# Attachment B- Staff Report

## City of Phoenix PLANNING & DEVELOPMENT DEPARTMENT

### Staff Report Z-SP-3-18-7 September 7, 2018

**Request From:** [C-2 BAOD](#) (10.27 acres)  
**Request To:** [C-2 SP BAOD](#) (10.27 acres)  
**Proposed Use** Special permit to allow self-service storage, household moving center (truck rental), and all underlying C-2 uses

### 4. **Site Plan**

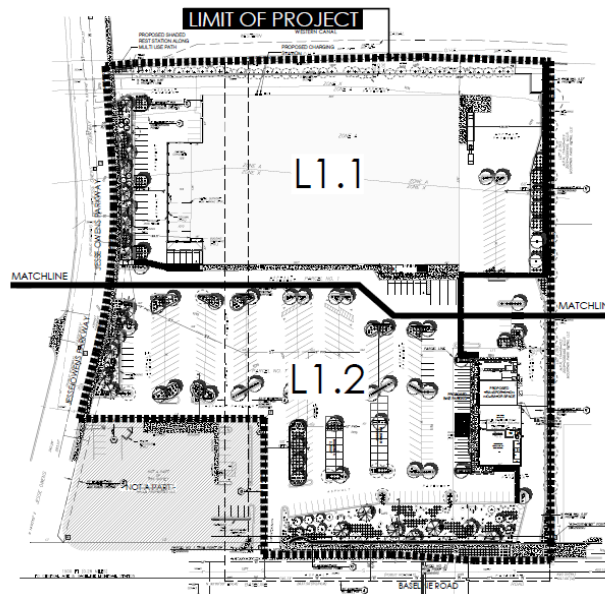
Staff does not recommend general conformance to the Overall Site Plan (see attached) submitted with the request. The subject site was permitted and developed prior to the adoption of the Baseline Area Overlay District and there are numerous features depicted on the site plan, reflecting the existing development, which would not comply with the current requirements of the requested C-2 SP BAOD zoning designation. These features include, but are not limited to the following:

- The site plan does not include shaded and raised walkways within the parking lot, which is a required design guideline of the BAOD (651.E.2.a).
- The site plan does not propose overhangs a minimum of 10 feet in width along all pedestrian walkways adjacent to buildings, which is a required design guideline of the BAOD (651.E.2.c).

improvements of existing commercial developments. Therefore, staff stipulations individually address particular areas of concern including BAOD requirements regarding the Baseline Road landscape setback, pedestrian walkways, parking lot landscaping, and landscaping in the project's main entry. See Background Item Nos. 8-12 for detailed discussion regarding these stipulations.

*Conceptual Elevations*  
 Source: Amerco Real Estate Company

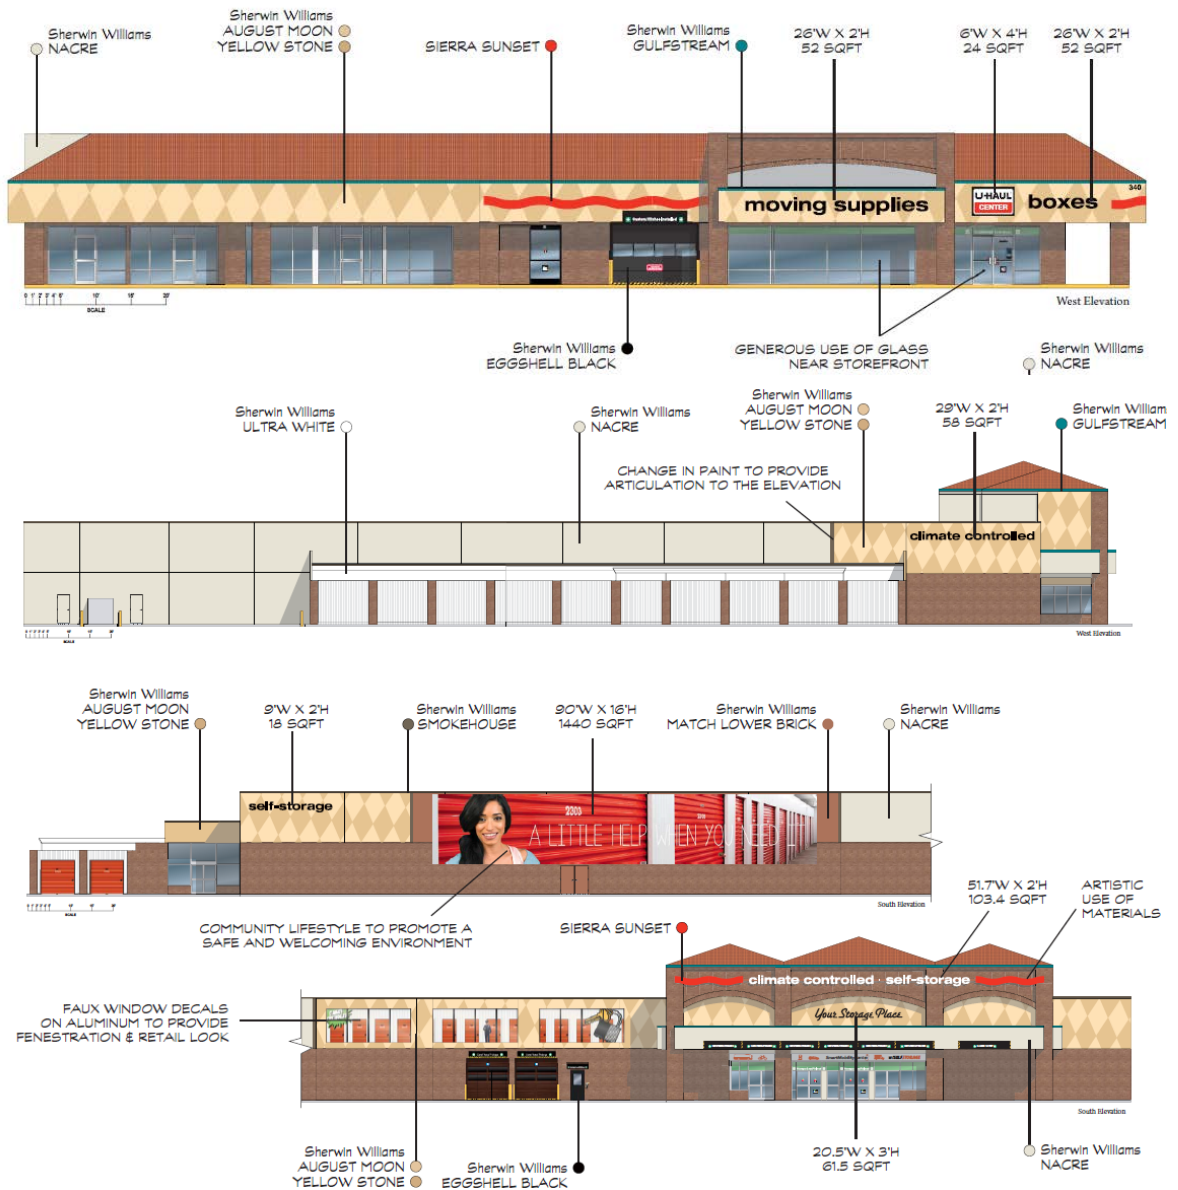
Staff does not recommend general conformance to the proposed elevations as they do not exceed the Guidelines for Design Review as outlined in Section 507. Tab A of the Zoning Ordinance.

Staff does recommend a requirement that all building elevations, including those facing or visible from the Western Canal, shall contain multiple exterior accent materials, architectural embellishments, and/or detailing such as green screens, textural changes, pilasters, offsets, recesses, variation in window size and location, and/or other overhang canopies. Providing these additional architectural elements will create visual interest for the site and help to mitigate the impacts of the building massing, particularly along the Western Canal. This is addressed in Stipulation No. 4.

*Preliminary Landscape Plan  
(Detail: Northeast corner of site)  
Source: Amerco Real Estate Company*

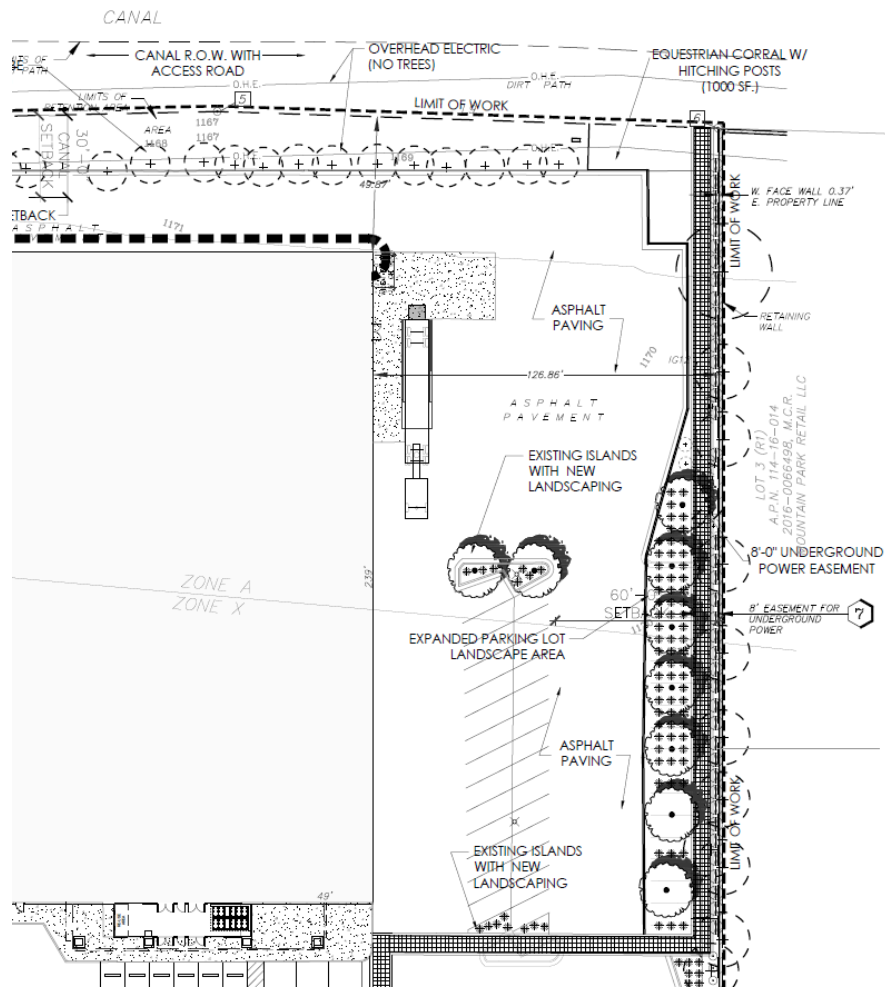
Stipulation No. 10 furthers the goal of this BAOD design guideline by requiring a pedestrian walkway which provides connectivity between Baseline Road and the Western Canal, as depicted on the Preliminary Landscape Plan date stamped August 1, 2018. This stipulation is intended to provide a connection between the walkways required by the BAOD within the parking lot and the north and south perimeter of the site to promote increased access to the amenities along the Western Canal and the multi-use trail along Baseline Road.

10. The developer shall provide a pedestrian walkway constructed of porous, interlocking, or open-grid pavers or another alternative surface material, which provides connectivity between Baseline Road and the Western Canal, as depicted on the Preliminary Landscape Plan date stamped August 1, 2018 and as approved by the Planning and Development Department.
